Dear Chair Fowler and Members of the Planning Commission:

Thank you for this opportunity to provide new testimony based on information and claims that have emerged since the start of the hearing process for LU-24-027.

In this memorandum I focus mainly on the issues of groundwater availability and groundwater quality. I will set forth the following series of numbered points, just briefly stated here, but elaborated further in Annex 1 of this memo.

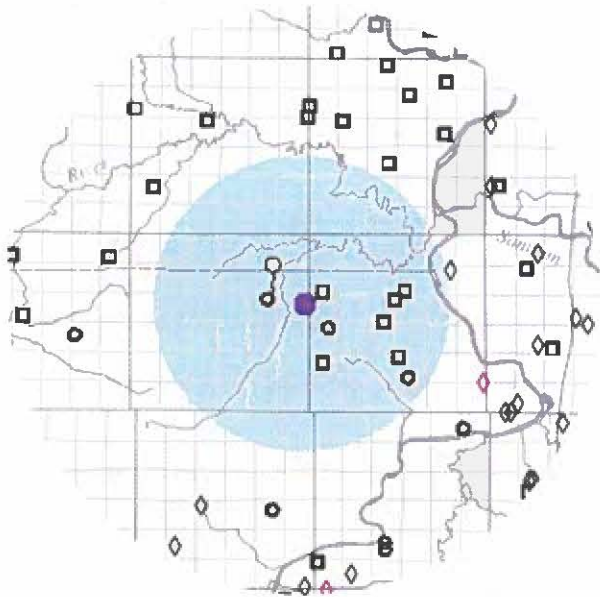
- They misconstrue statements about data sparseness in the mountainous portions of eastern Linn and Lane counties, as if they apply to the Willamette Valley as a whole;
- They misleadingly suggest that, because the study included specific datasets from Linn and Lane counties, that data are lacking from the vicinity of Coffin Butte;
- They misconstrue statements about "volcanic rock of rhyolitic to intermediate composition," as if they apply to volcanic rock in general.

In fact, the dataset used in the USGS study included 9 domestic wells and 1 natural spring within 5 miles of Coffin Butte Landfill, plus 40 additional wells that were within 10 miles (Figure 1). Only one of those 50 data sources showed arsenic levels above 10 µg/L (the EPA maximum contaminant limit for drinking water). One of those points is adjacent to the Springhill Golf Course in North Albany, and the other is adjacent to OSU's experimental farms near Peoria Road, both locations where arsenic-based weed-killers from past decades are a plausible source. None showed arsenic levels above 50 µg/L, in stark contrast to what has been observed at Coffin Butte.

Their meaning is further made clear by their Plate 1, which has been submitted as part of the record. The areas lacking data are mainly in the Cascades portion of the basin, or the deeper parts of the Coast Range.

Figure 3. Arsenic and chloride levels in compliance-boundary wells MW-26 and MW-27 as plotted by VLI's consultants in Exhibit 49. Note that chloride is plotted in milligrams per liter (parts per million) while arsenic is plotted in micrograms per liter (parts per billion).

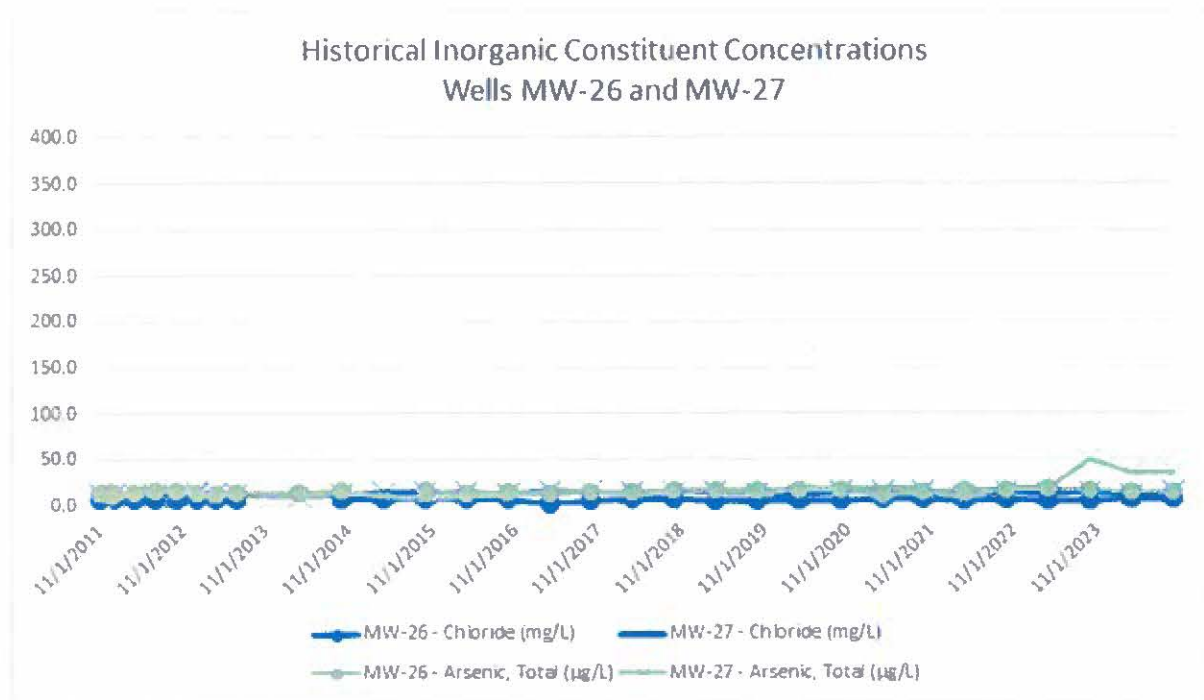
VLI's presentation of data from monitoring wells at Coffin Butte is also misleading. In presenting historical data on arsenic at Coffin Butte, they misleadingly plot data on a strangely chosen scale, with a maximum 10 times the range of the data (Figure 3). The effect is to conceal the strong fluctuations over time which are evident in a more scientifically reasonable presentation of the same data, as used in their Annual Environmental Monitoring Reports (Figure 4).

Note that the first plot in Exhibit 49 shows no arsenic measurements above 50 micrograms per liter ($\mu\text{g/L}$), but values up to 68 $\mu\text{g/L}$ have been measured in a nearby well more recently. VLI's consultants are certainly aware of those recent high values.

Figure 5. Arsenic and chloride levels in MW-9S as plotted by VLI's consultants in Exhibit 49.

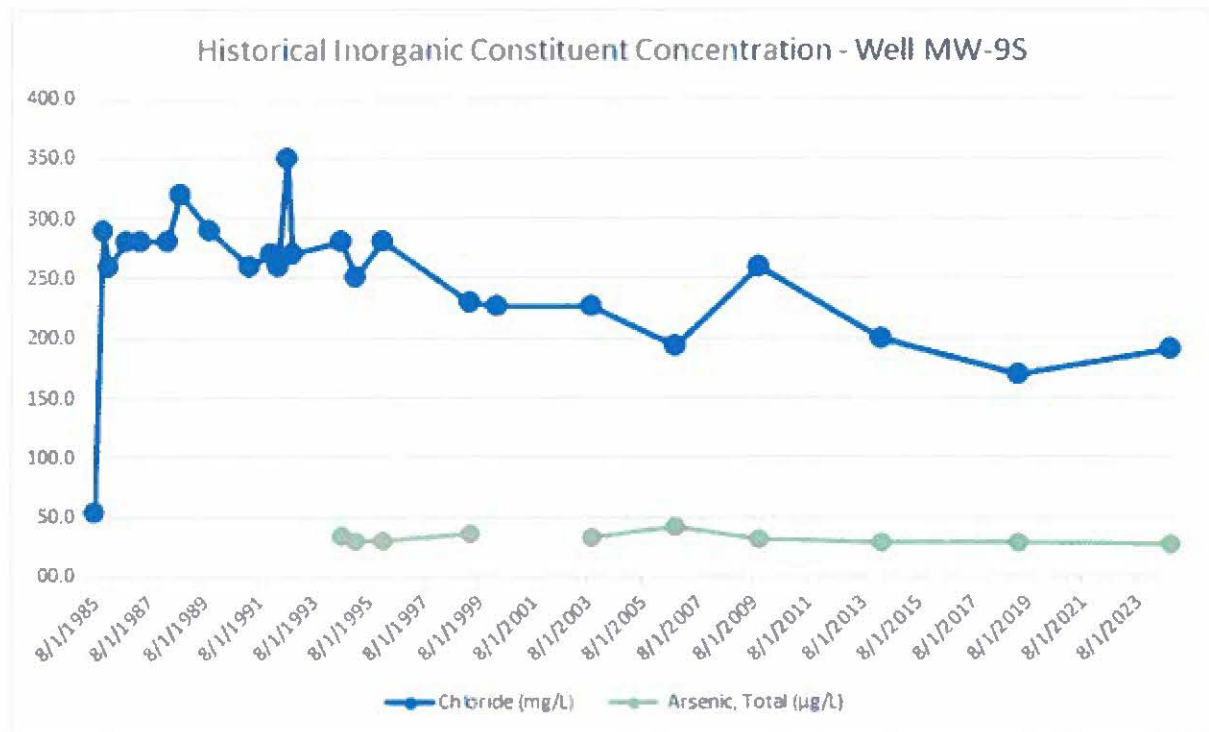
In the applicant's attempt to defray concerns about arsenic, they suggest that chloride is a better indicator. The second plot in Exhibit 49 (reproduced here as Figure 5) shows that the initial measurement of chloride in MW-9S was about 50 mg/L, but soon afterward the concentration jumped by nearly a factor of 6.

Though this declined somewhat after the seepage problem was discovered in the mid-1990s, and corrective actions were taken, chloride in MW-9S has remained more than a factor of 3 above the initial baseline value, ever since. Far from alleviating concerns about leakage from Cell 2, this plot elevates concerns about potential for ongoing contamination of the Willamette Basin aquifer.
